Re: Application of Row 44, Inc. for Special Temporary Authority
FCC File No. SES-STA-20080711-00928; Call Sign E080100

PETITION TO DENY OF VIASAT, INC.

REPLY OF VIASAT, INC.

Two-Way Fuselage Mount Antenna Transmit Gain

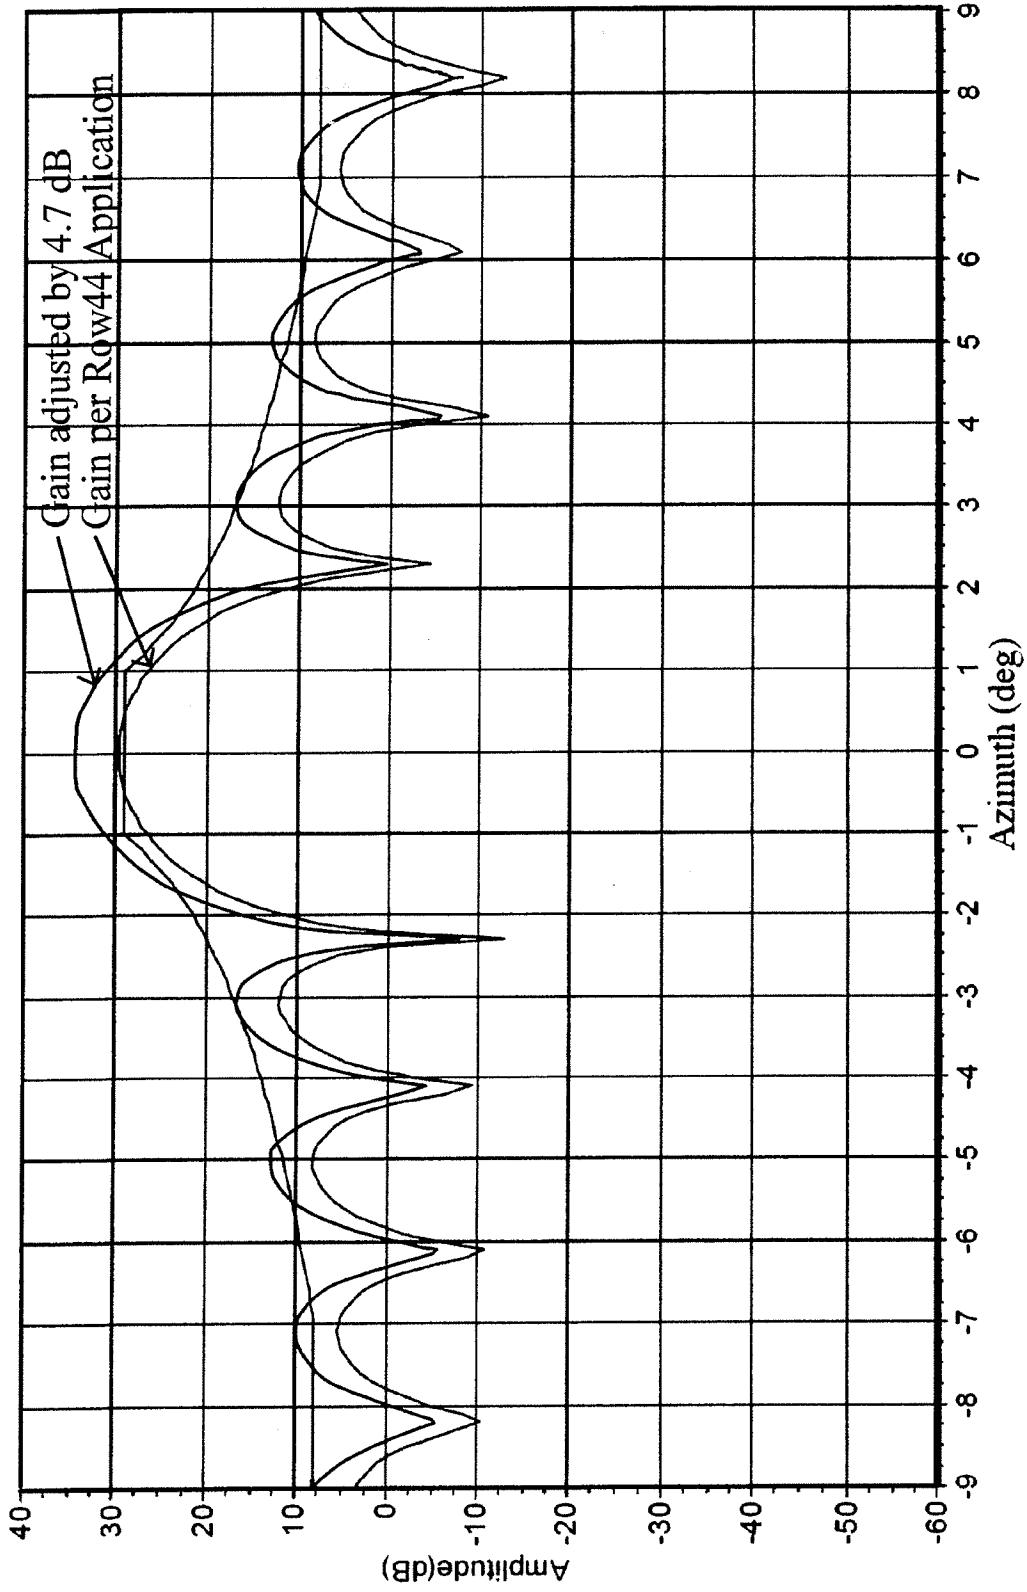
Row 44's approach has the effect of artificially depressing the antenna gain reported in the Application. As shown in Exhibit 1, when calculated using the standard methodology based on specifications published by the manufacturer of the proposed antenna (Aerosat), Row 44's transmit antenna gain is not compliant with the Section 25.209 antenna mask.⁴¹ Notably, Row 44 seeks no waiver of Section 25.209. Further, to the extent that Row 44 seeks to rely on this "line loss" to reduce the expected power level that would be input to the antenna, Row 44 fails to explain whether this line loss is representative of each application of its technology, or whether the length of the "transmit flexible-waveguide structure" that produces this loss would vary among the different aircraft types that may utilize the Row 44 system.

The 4.7 dB adjustment value is the difference between the 33.3 dBi gain specified in marketing materials released by the manufacturer (Aerosat) and the 28.6 dBi gain provided by Row 44 in the Application.

14.3 GHz Elevation Vertical Polarization

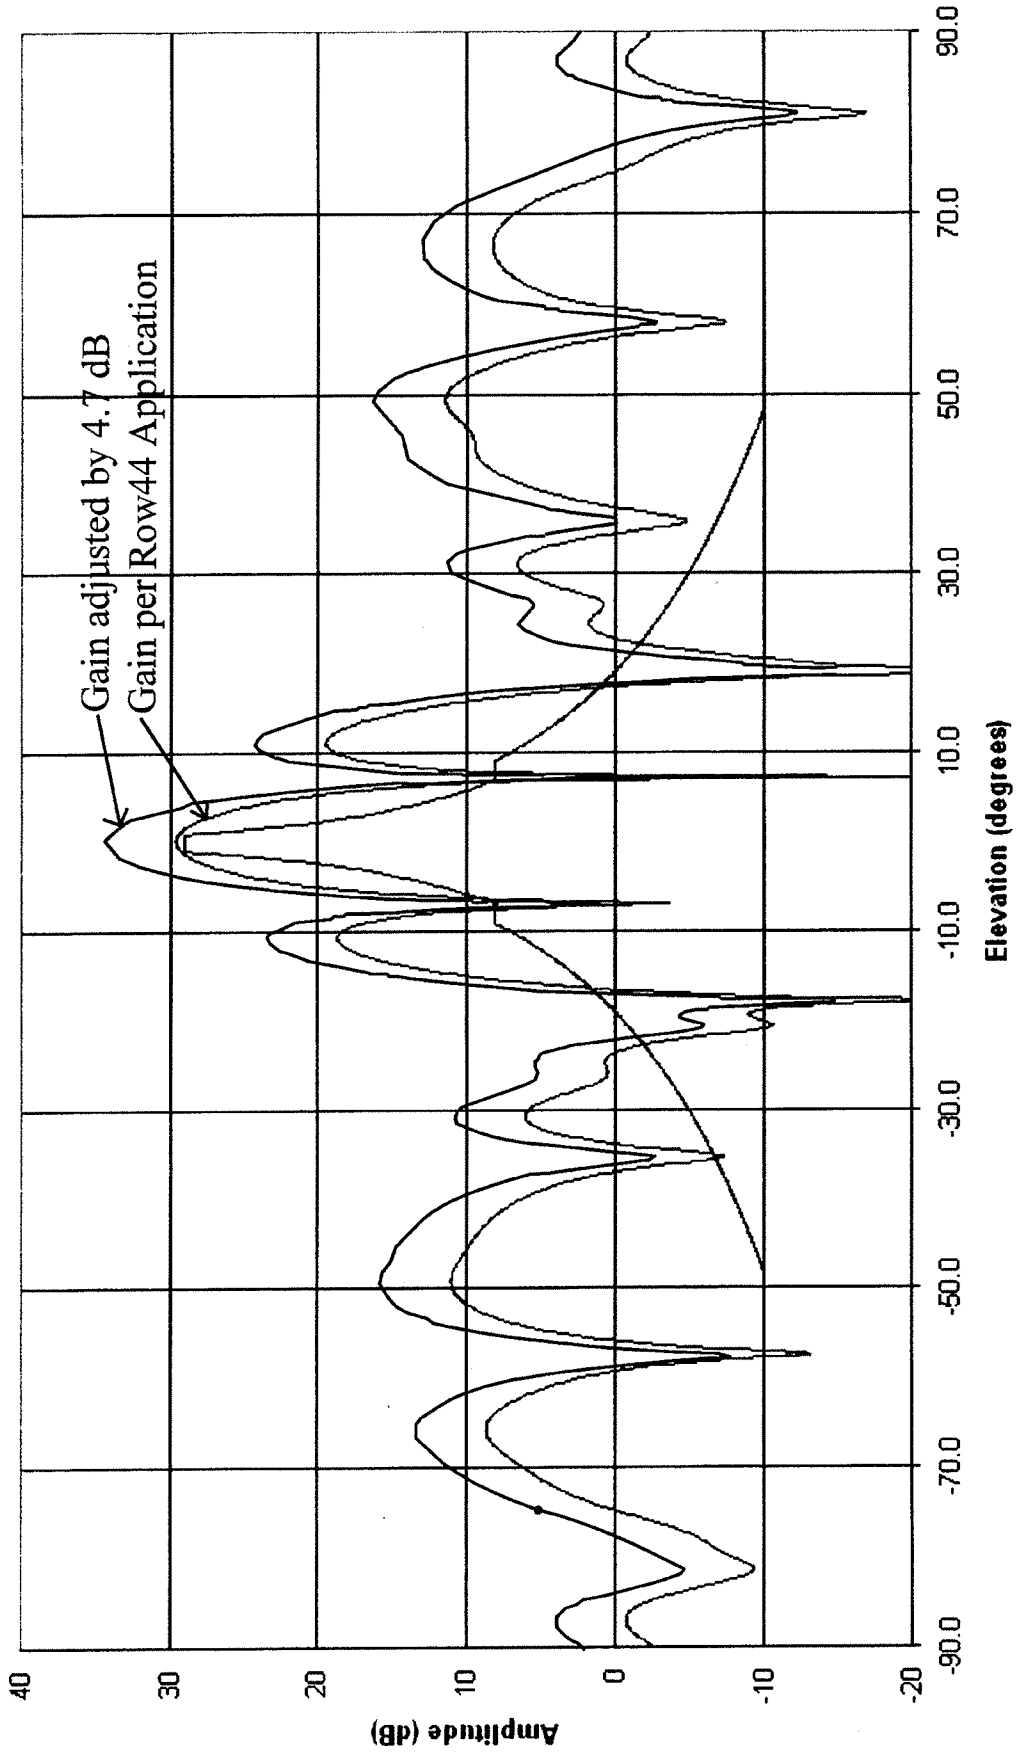
The 4.7 dB adjustment value is the difference between the 33.3 dBi gain specified in marketing materials released by the manufacturer (Aerosat) and the 28.6 dBi gain provided by Row 44 in the Application.
